SUBJECT: R.E. Ginna Nuclear Power Plant
Docket No. 50-244

**Final Response to Requests for Additional Information Regarding Topics
Discussed on Conference Calls for Extended Power Uprate (EPU)**

**RESPONSE TO NRC REQUEST FOR ADDITIONAL INFORMATION ON THE R. E. GINNA
EXTENDED POWER UPRATING**

Figure 2.8.5.4.2-4
Rod Withdrawal at Power – DNB Case
Maximum Reactivity Feedback – 100% Power - 5 pcm/sec
Nuclear Power and Heat Flux vs. Time

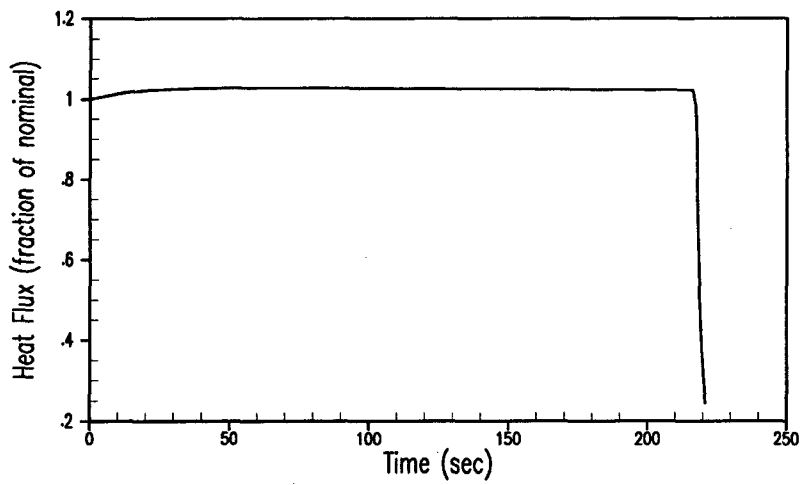
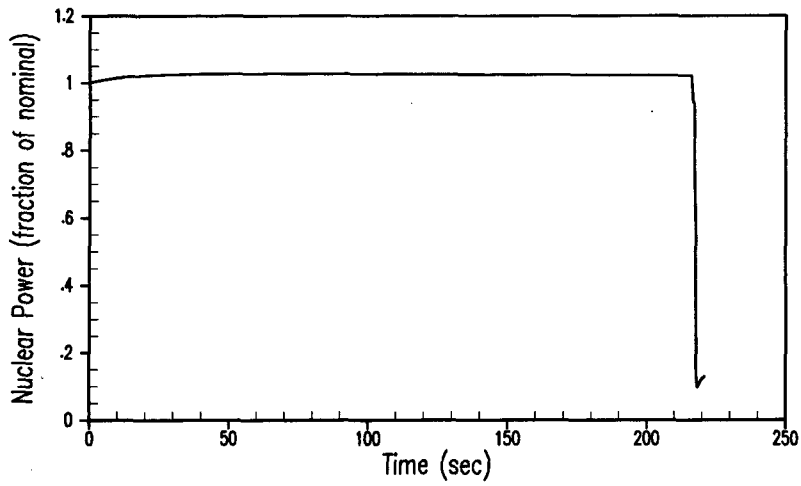
- Section 2.8.5.4.2.3 Results. In the second paragraph, the word 'minimum' should be 'maximum' (...from 100% power with maximumfeedback is shown in Figures 2.8.5.4.2-4...)
- Label for Figure 2.8.5.4.2-4 the word Minimum should be changed to Maximum.
- Label for Figure 2.8.5.4.2-5 the word Minimum should be changed to Maximum.
- Label for Figure 2.8.5.4.2-6 the word Minimum should be changed to Maximum.

Deleted: Minimum
